Re: Comments and Request for a Meeting and a Hearing Regarding Lakeside Georgetown LLC. proposed Texas Land Application Permit (TLAP) No. WQ0016499001

Background. Lakeside Estates Georgetown, LLC, 4126 Remington Road, Cedar Park, Texas 78613, has applied to the Texas Commission on Environmental Quality (TCEQ) for a new permit, Proposed TCEQ Permit No. WQ0016499001 to authorize the disposal of treated domestic wastewater at a daily average flow not to exceed 380,000 gallons per day via surface irrigation of 101 acres of public access residential green space.

Figure 1: Soil Type Maps for Lakeside Estates

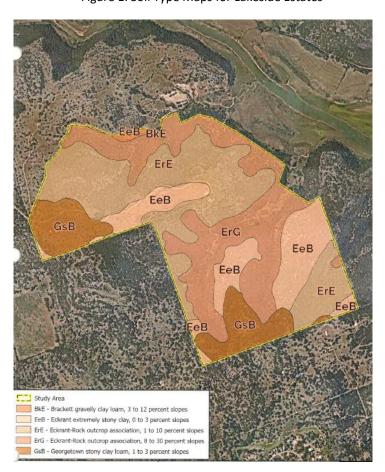
- c. <u>Soil Types and Runoff Impacts:</u> As noted in the permit application, the soil types in the project area include: a) Eckrant-Rock outcrop (ErE), b) Eckrant-Rock outcrop (ErG), c) Eckrant extremely stony clay (EeB), d) Georgetown stony clay loam (GsB), and e) Brackett gravelly clay loam (BkE) (Figure 1)

As can be seen from Fig. 1, majority of the soils found within the Lakeside Estates area fall within the Eckrant soil family. In fact, 85.7% of the soils in Lakeside Estates are Eckrant soil types. The Eckrant soil type is classified as a "Group D" soil under the United States Department of Agriculture's Hydrologic Soil Groups. A "Group D" soil type means the soil has a very slow infiltration rate when wetted, indicating they also have a very high runoff potential. Further, the other soil types found within the Lakeside Estates area, Brackett gravelly clay loam and Georgetown stony clay loam, have a "Group C and D" hydrologic soil type designation respectively. A "Group C" designation indicates the soil has a slow infiltration rate when wetted, indicating a high runoff potential. The types of soils found throughout the Lakeside Estates development raise concerns about runoff potential of effluent and stormwater runoff into surrounding wells, lands, and waterbodies due to increased risk of oversaturated irrigation areas across the development
